## UNCC - CID Phase II Wi-Fi

## BID ADDENDA No. 02

University of NC at Charlotte  
CID Phase II Wi-Fi

Clark Nexsen Comm. No. 5462  
State Project ID: 13-10724-01A  
Code: 41326 Item: 307

2 ALTERNATE #2 KING - FIRST FLOOR PLAN  
1/8"=1'-0"

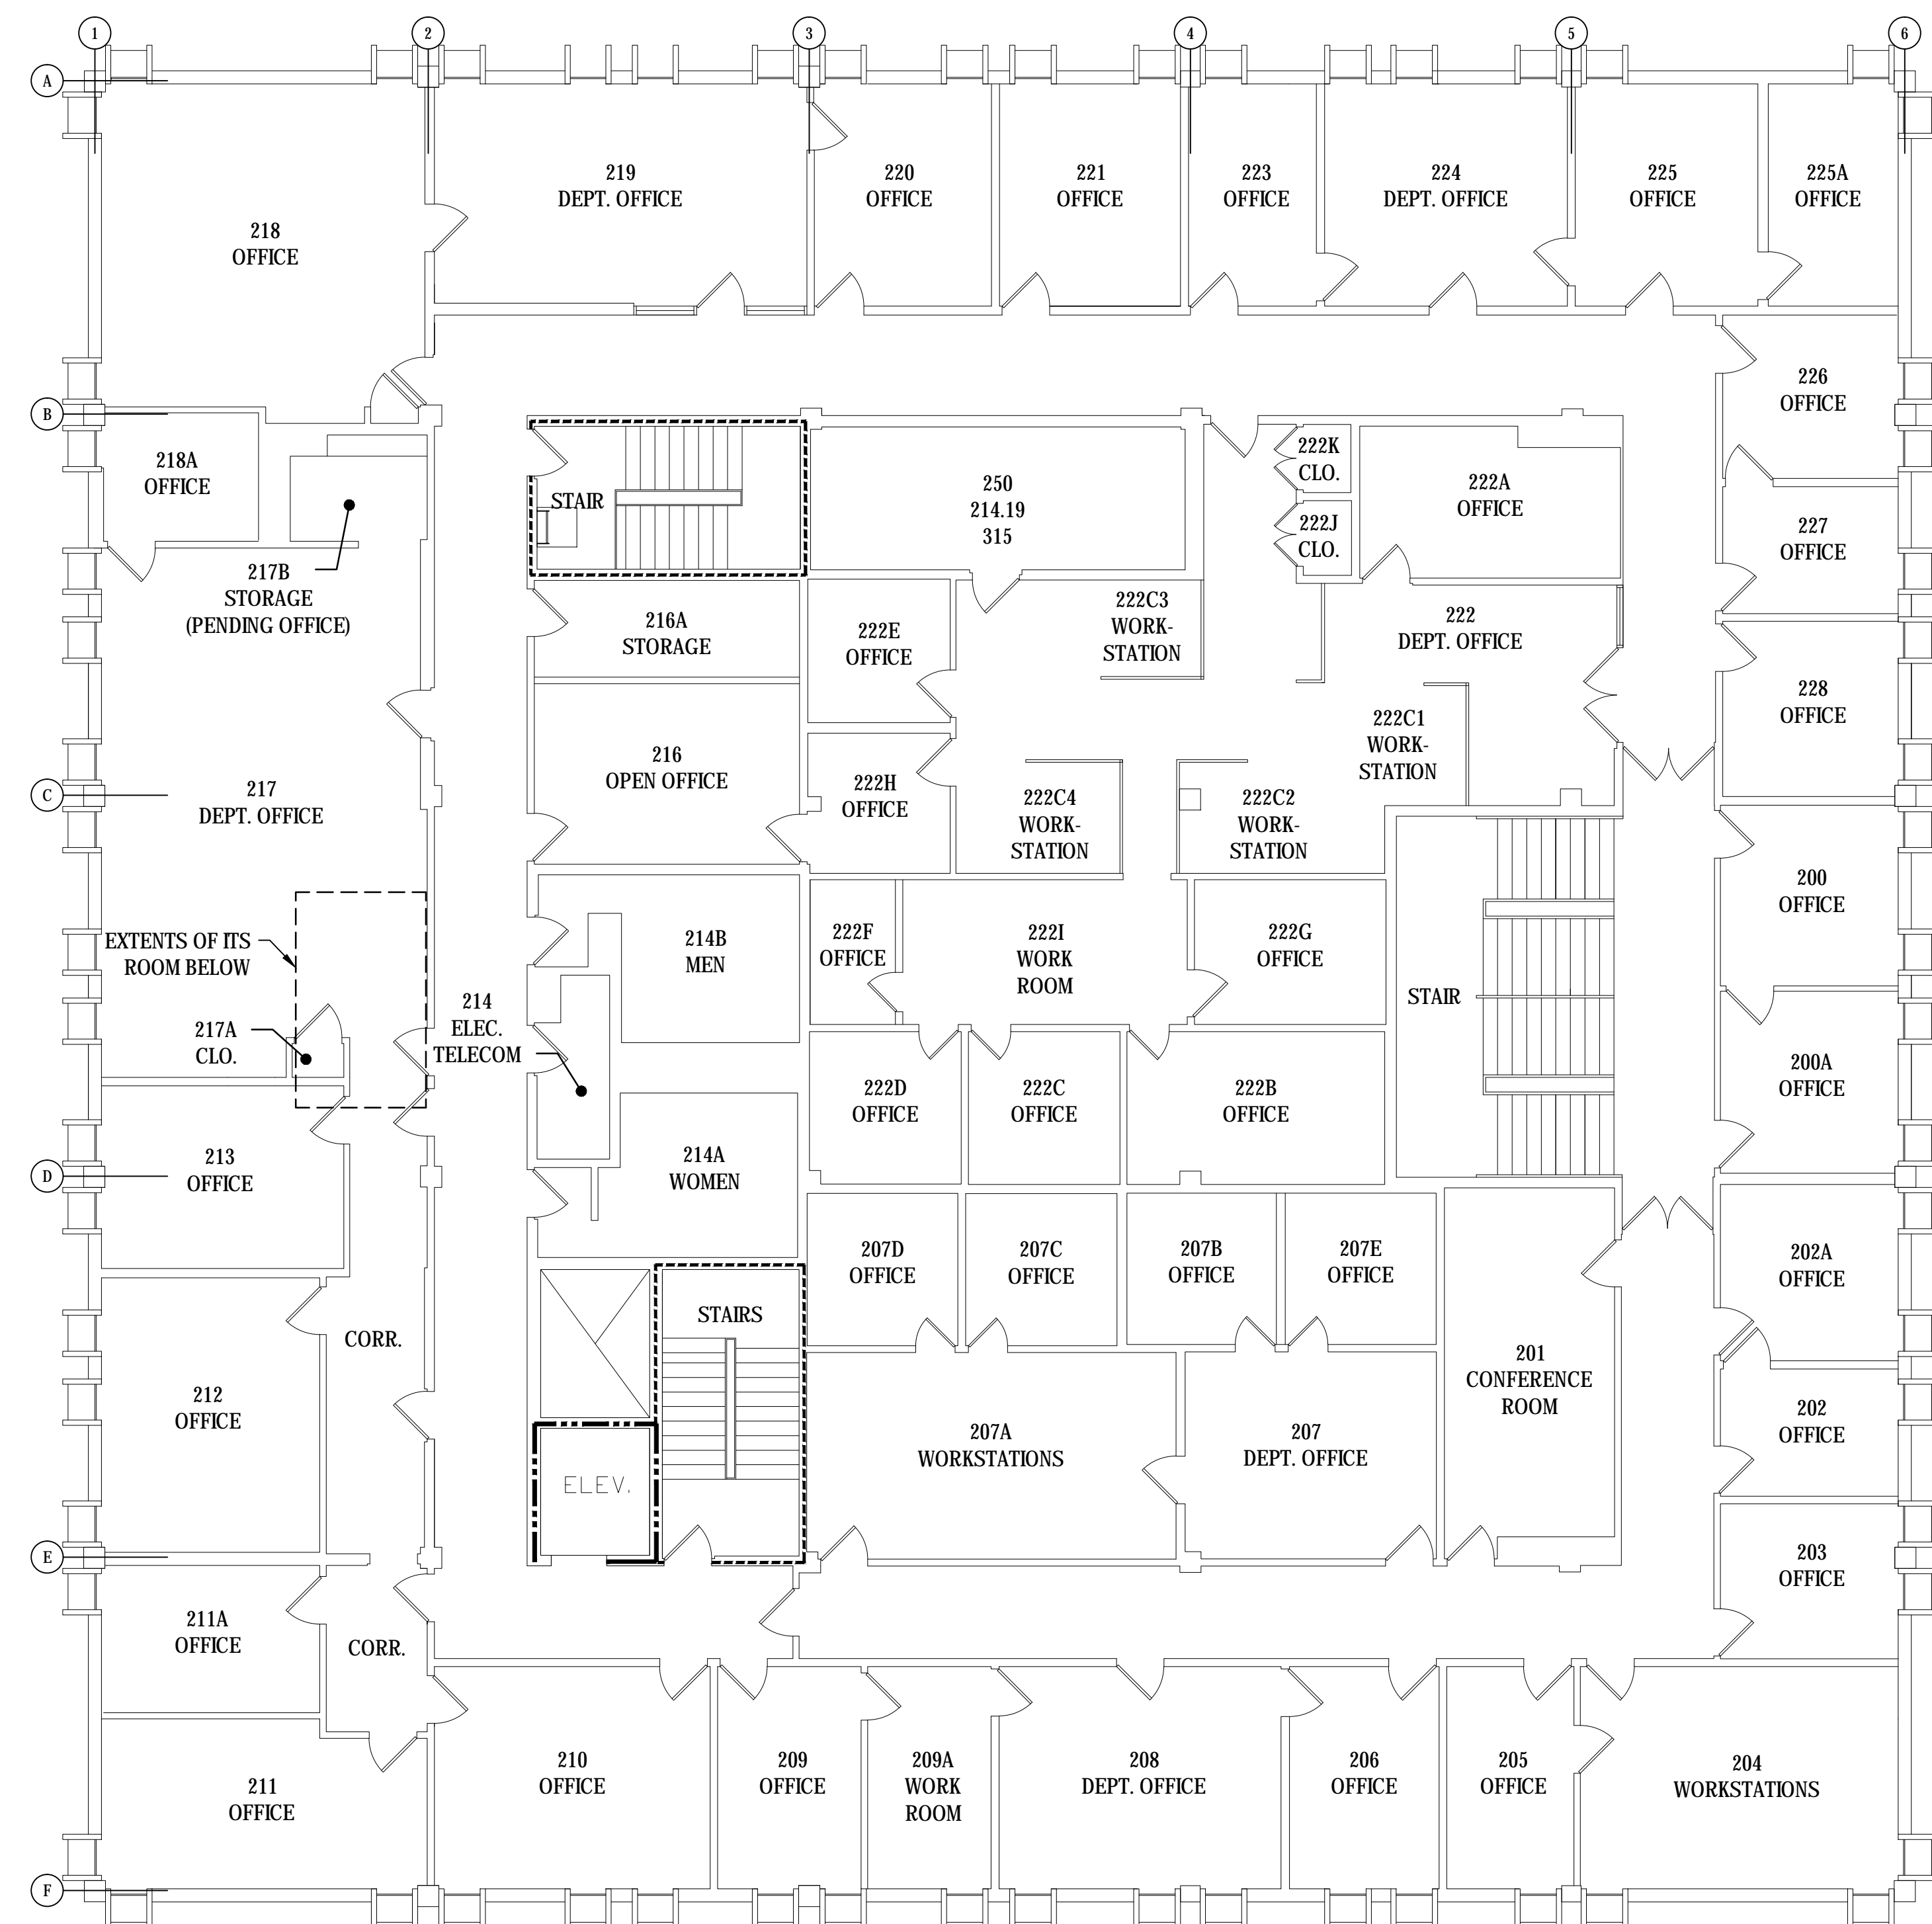
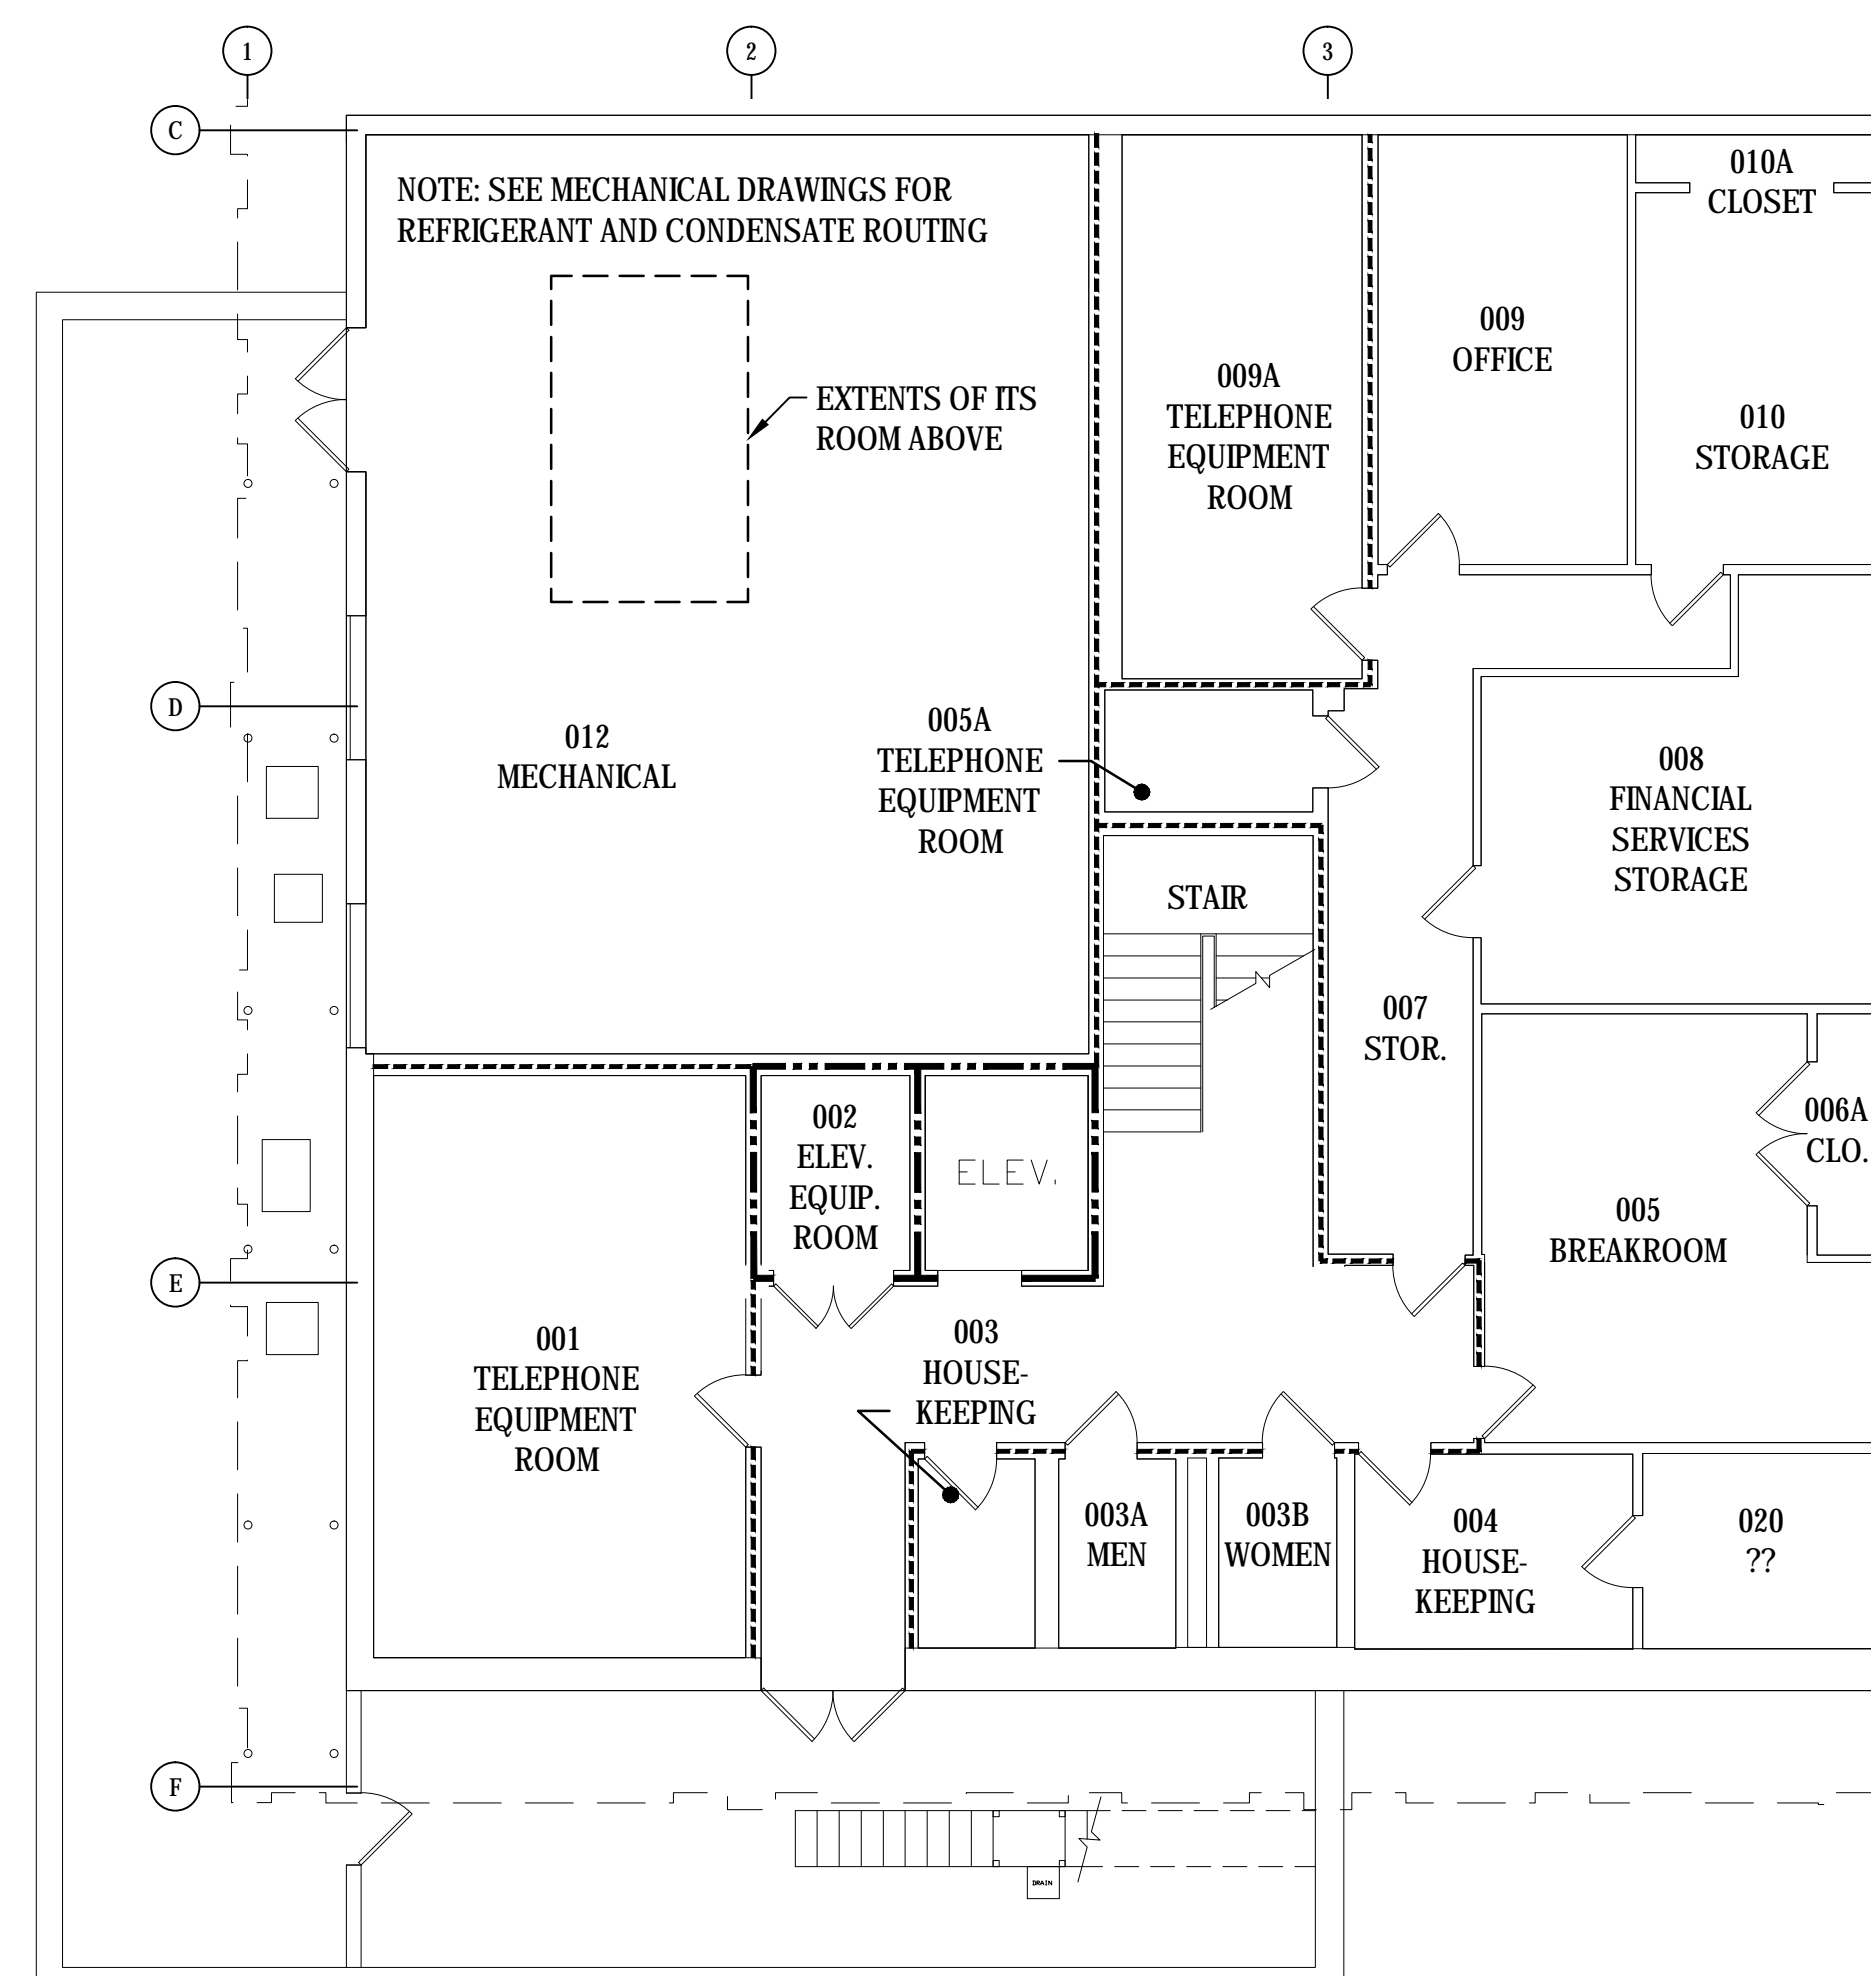
- Detail #4, ALTERNATE #2 KING – ROOM 121 has been renumbered to detail #3.
- Detail #5, ALTERNATE #2 KING – DEMOLITION PLAN has been renumbered to Detail #4.
- New work added to Work Room 119B.
- Construction Note #16 added to dual light switches in Office 119.
